**HANNEY & ASSOCIATES ARCHITECTS**  
1726 South Hillside, Wichita, Kansas

**NOTICE TO BIDDERS**

You are hereby instructed to include in your bids the following changes and/or corrections to the Drawings and Specifications for the Gym Addition at Garden Plain High School in Garden Plain, Kansas. The additions and/or corrections shall be considered as a part of the Contract Documents as if incorporated therein. Where the following corrections and/or additions vary from the conditions of the Drawings and Specifications, such following changes or additions shall govern.

M2.1 MECHANICAL FLOOR PLAN ADDENDUM NO. 4

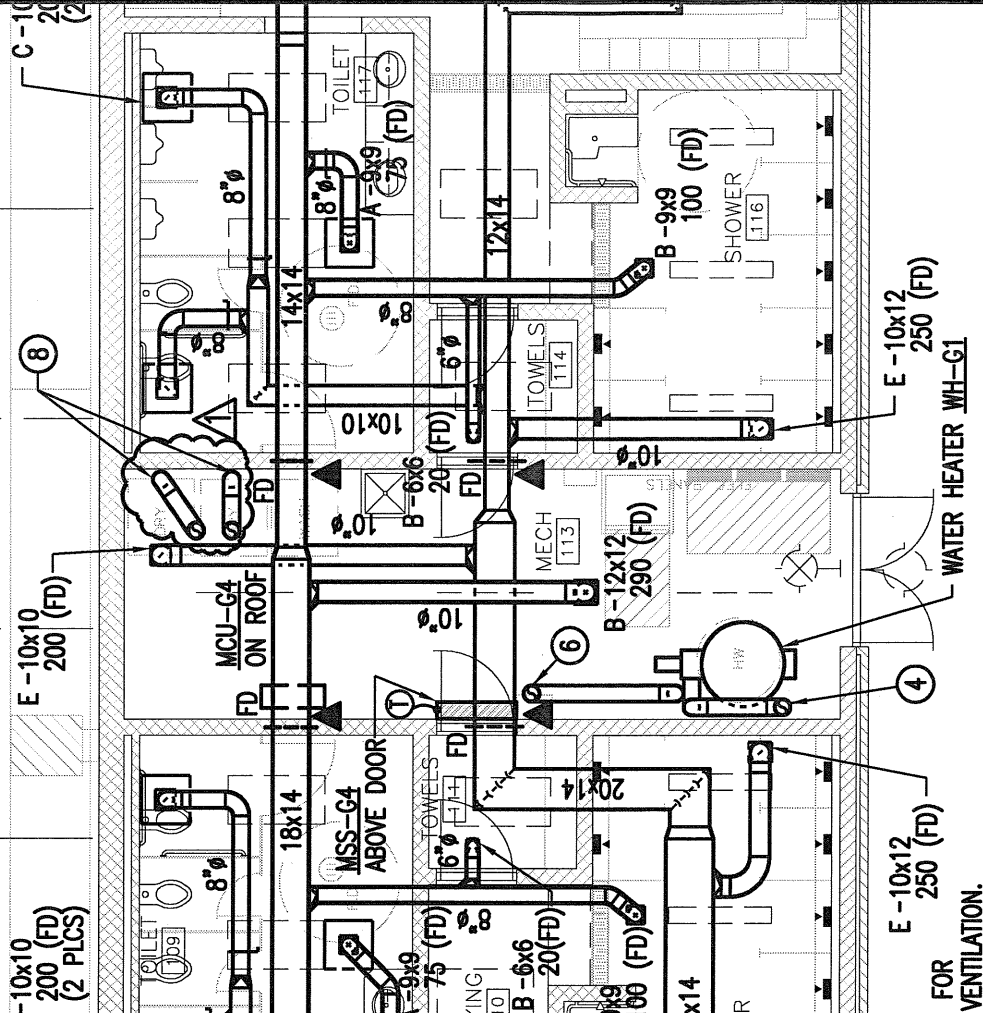
- 2.17 Sheet M2.1
  - 2.17.1 Mechanical Floor Plan: See the enclosed partial revised plan.
  - 2.17.2 Delete the "FG" fixture in Toilet 117 and 109 and replace with four "F4" fixtures each. "F4" fixtures are to be mounted in the soffit that runs the entire length of the wall. See architectural detail 3/A2.1. Reference Sheet E1.1 and E3.1
